Subject: AP1000 Response to Request for Additional Information (SRP 3)

RAI-SRP3.8.3-SEB1-04 R1

AP1000 TECHNICAL REPORT REVIEW

RAI Response Number: RAI-SRP3.8.3-SEB1-04

Figure RAI-SRP-3.8.3-SEB1-04-01
Typical detail at base of CA01 Module Wall with single layer of dowel bars

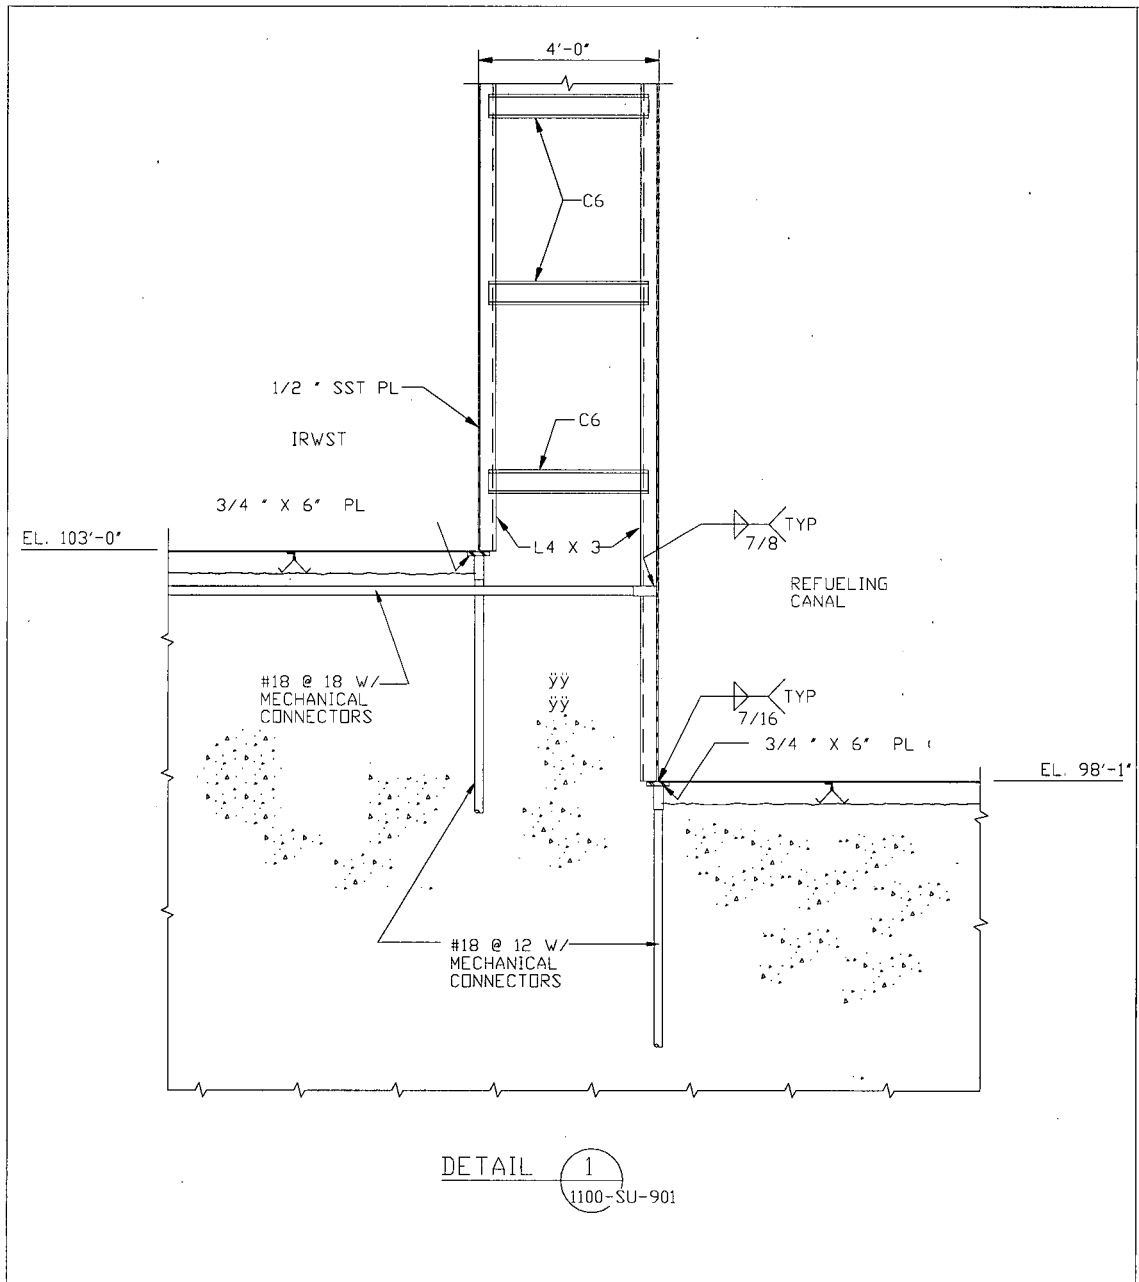
1. The left side of Figure 3.8.3-8, sheet 2, shows that the mechanical connectors that are welded to a $\frac{3}{4}$ inch plate at the base of the module is identified as "CONT" (presumably meaning continuous) on one side of the module and on the other side the term "CONT" is struck out. Explain which detail is correct and revise the figure accordingly. Were the design detail calculations completed for this connection? Explain how the large loads coming from the CIS wall modules can be properly transferred from the module wall plate at a localized point to the embedded connectors.

1. The plate at the base of the module does not need to be continuous. The revised typical detail is shown in Figure RAI-SRP-3.8.3-SEB1-04-01 and will be included in the DCD. An alternate version of this detail is used in cases where the trusses are extended into the basemat as shown in RAI-SRP-3.8.3-SEB1-04-02. The vertical dowel bars are placed in two layers. The base plate is stiffened to transfer the loads from the module wall plate to the embedded connectors. The design of the surface plate, base plate, and vertical stiffeners is checked by finite element analysis using the model shown in Figure

Delete "cont" from left side of DCD Rev 17 Figure 3.8.3-8, sheet 2, as shown corrected in Figure RAI-SRP3.8.3-SEB1-04-01.

Figure RAI-SRP-3.8.3-SEB1-04-01A

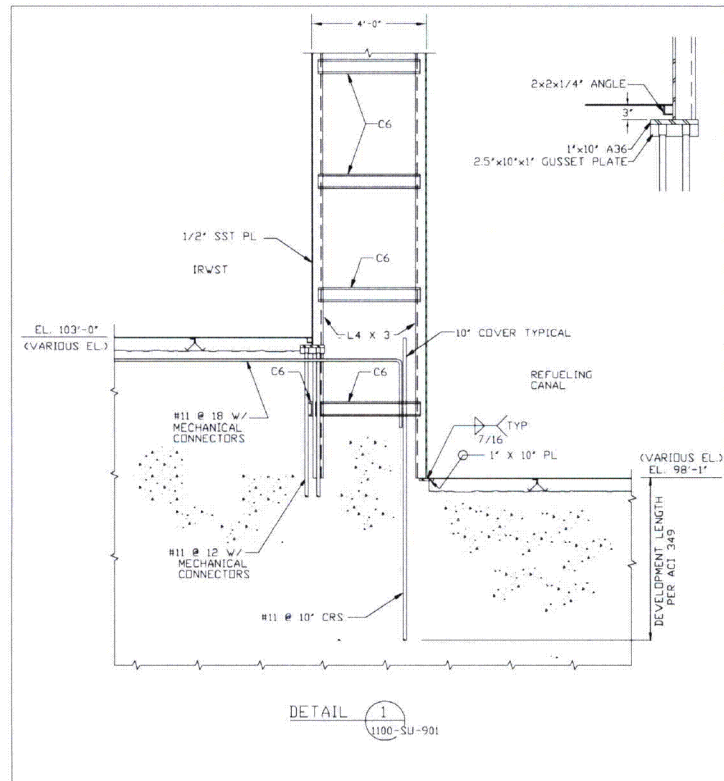
Provide information on the connection of structural modules to base concrete in the RAI response.

The revised typical detail is shown in Figure RAI-SRP-3.8.3-SEB1-04-01A and provides information on the connection of structural modules to base concrete. The revised DCD figure is provided.

Replace the left side of DCD Rev 17 Figure 3.8.3-8, Sheet 2, with Figure RAI-SRP-3.8.3-SEB1-04-01A, Typical detail at base of CA01 Module Wall with single layer of dowel bars (Note: Spacing, type of the bars and size of the plates are various). The updated DCD Figure 3.8.3-8, Sheet 2 is provided as Page 7 of this response.
